**2nd 15-DAY EXPRESS TERMS
FOR
PROPOSED BUILDING STANDARDS
OF THE
DIVISION OF THE STATE ARCHITECT (DSA-AC)

REGARDING THE CALIFORNIA BUILDING CODE
CALIFORNIA CODE OF REGULATIONS, TITLE 24, PART 2

2013 CALIFORNIA BUILDING CODE**

**Figure 11B-604.8.1.2
Wheelchair Accessible Toilet Compartment Doors**

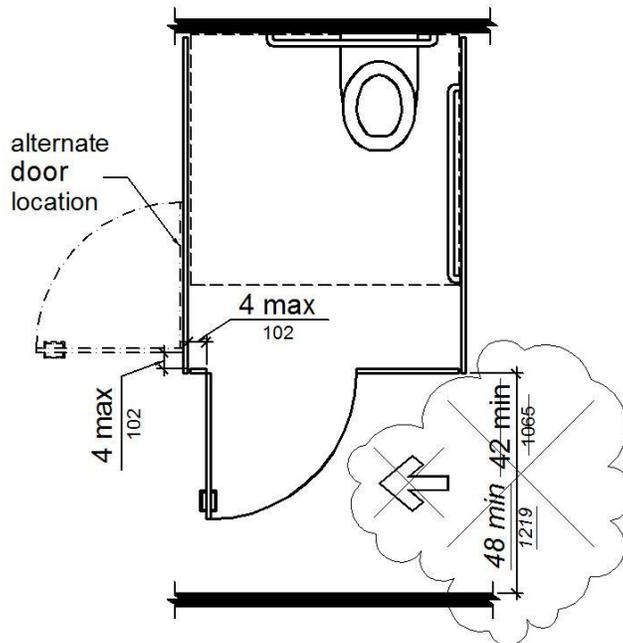
11B-604.8.1.2 Doors. Toilet compartment doors, including door hardware, shall comply with 11B-404 except that if the approach is (begin double strikeout) to the latch side (end double strikeout) (begin double underline) from the push side (end double underline) of the compartment door, clearance between the door side of the compartment and any obstruction shall be (begin single strikeout) 42 inches (1065 mm) (end single strikeout) (begin single underline) 48 inches (1219 mm) (end single underline) minimum (begin single underline) measured perpendicular to the compartment door in its closed position. (end single underline) Doors shall be located in the front partition or in the side wall or

partition farthest from the water closet. Where located in the front partition, the door opening shall be 4 inches (102 mm) maximum from the side wall or partition farthest from the water closet. Where located in the side wall or partition, the door opening shall be 4 inches (102 mm) maximum from the front partition. The door shall be self-closing. A door pull complying with 11B-404.2.7 shall be placed on both sides of the door near the latch. ~~(begin single strikeout) Toilet compartment doors shall not swing into the minimum required compartment area. (end single strikeout) (begin single underline)~~ Doors shall not swing into the clear floor space or clearance required for any fixture. Doors may swing into that portion of maneuvering space which does not overlap the clearance required at a water closet. (end single underline)

(begin single underline) EXCEPTION: When located at the side of a toilet compartment, the toilet compartment door opening shall provide a clear width of 34 inches (864 mm) minimum. (end single underline)

RATIONALE: DSA-AC received public comment requesting clarification of the 45-Day Express Terms amendments to this section. DSA-AC is proposing to further amend this section to clarify that the required 48 inch minimum clearance between the door side of the compartment and any obstruction is applicable only when the approach is from the push side of the compartment door. Toilet compartment doors shall comply with 11B-404, specifically Table 11B-404.2.4.1, when the approach is from the pull side of the compartment door. DSA-AC is making corresponding changes to Figure 11B-604.8.1.2. These changes will provide clarity and consistency for code users.
